REGIONAL REVIEW FINDING

ARC REVIEW CODE: R1801181

Name of Proposal: South Fulton Parkway at Stonewall Tell (DRI 2745)

PRELIMINARY SITE PLAN

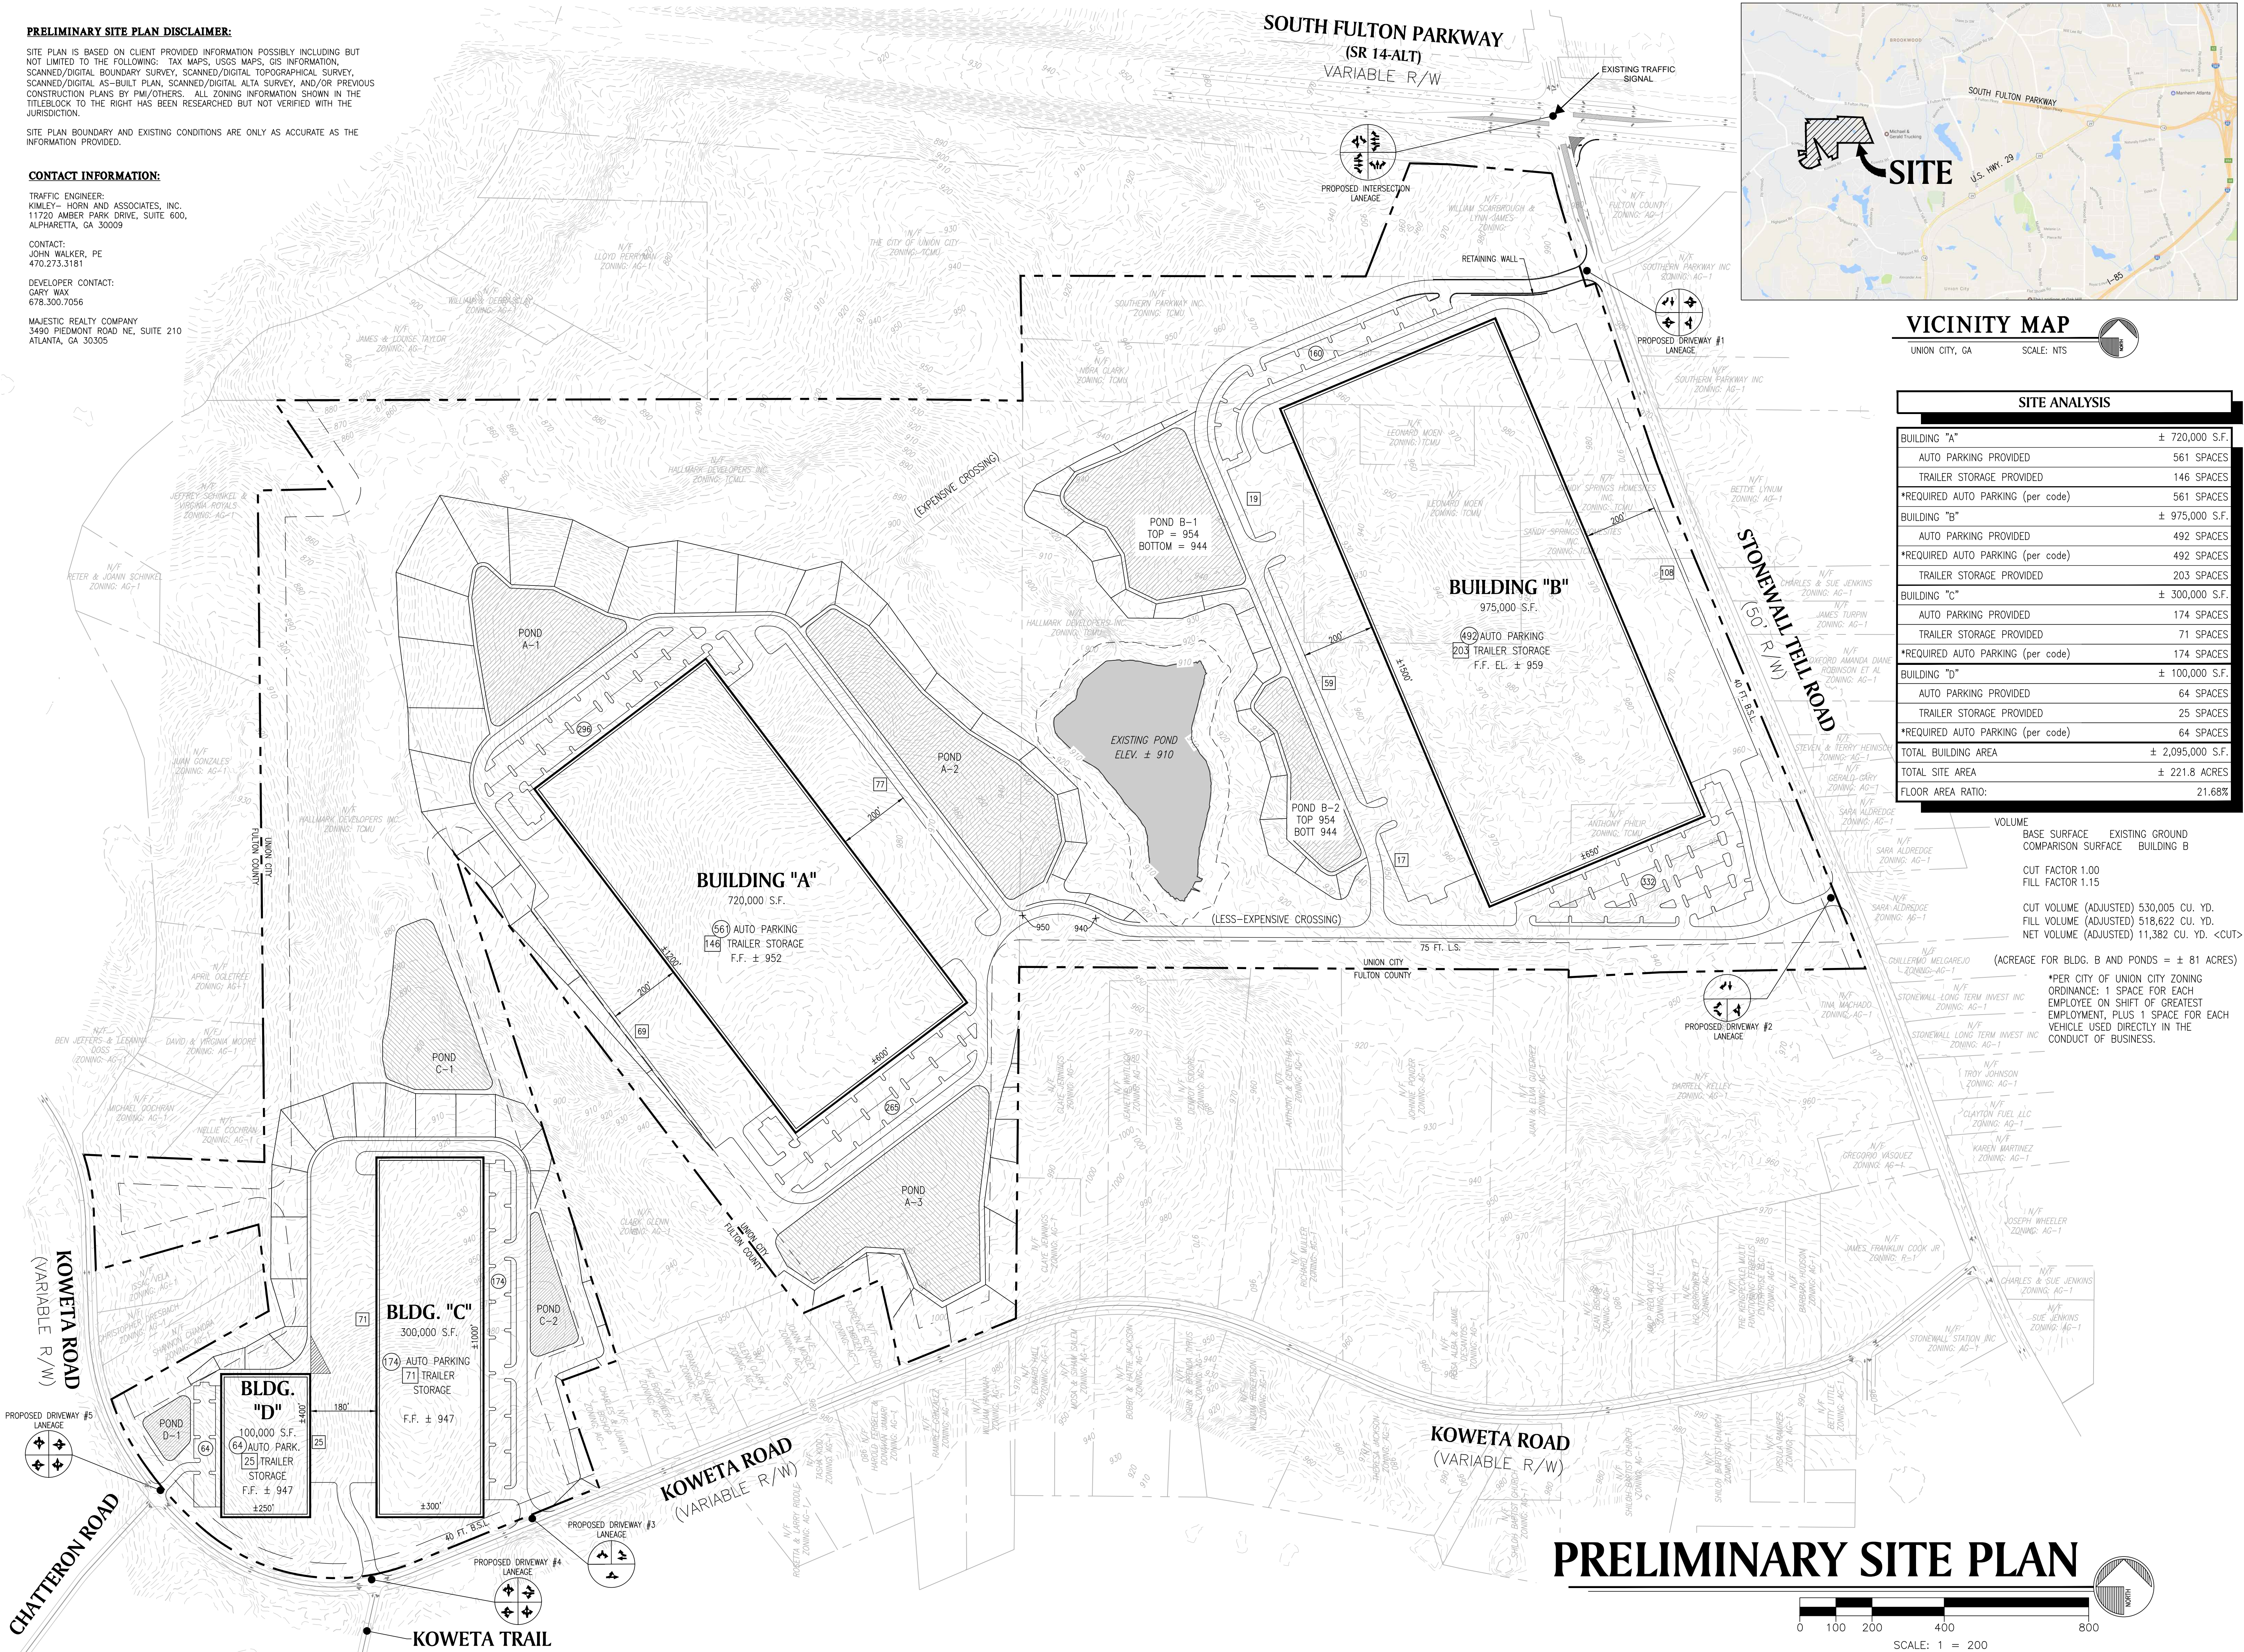
Connections to adjacent parcels can be made by local roads however adjacent uses are not compatible with proposed development use.

The site plan proposes 1291 parking spaces. The development does not propose bicycle and pedestrian facilities. Pedestrians, cyclist, vehicles and freight trucks will utilize the same driveways to move throughout the development.

The site plan does not provide specific information or depictions of bicycle and pedestrian facilities.

All five site access points allow for the both vehicle and freight access.
